Village of Bayside  
9075 N. Regent Rd.  
Architectural Review Committee Meeting  
August 5, 2019  
Village Board Room, 6:00pm

**ARCHITECTURAL REVIEW COMMITTEE  
AGENDA**

Attention:  
Village of Bayside, WI  
Architecture Review Committee

<p>PROJECT/SITE OWNER: Sarah and Ryan Donovan</p> <p>PROJECT ADDRESS: 9030 N Fielding Rd</p>	<p>PROJECT SUMMARY: New rear yard fence. 37' long, 4' tall cedar. 33% open design. Natural weathered finish.</p>
--	--

# Plat of Survey

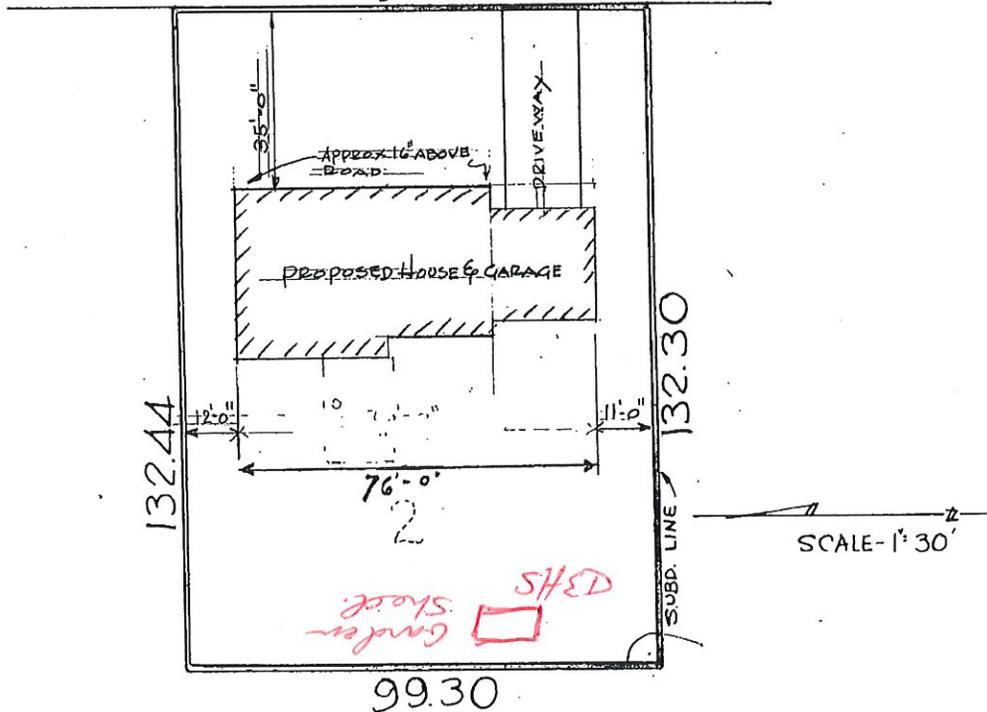
Shed location shall comply with setback requirements for rear yard. Minimum of 10 feet from rear property line.

**NEW SHED COMPLIES WITH VILLAGE CODE.**

#### **MATERIAL / FINISH:**

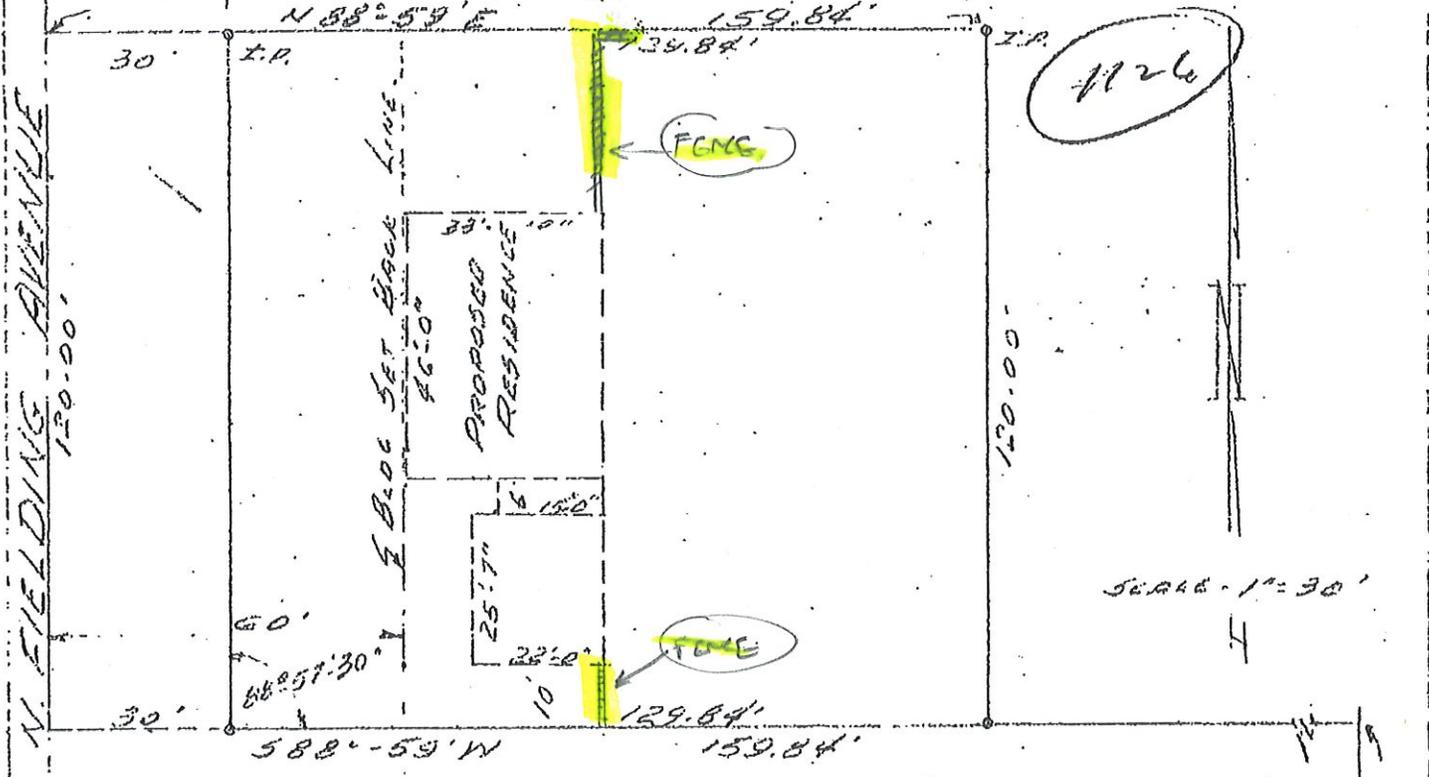
#### **PROPOSED MATERIAL / FINISH COMPLIES**
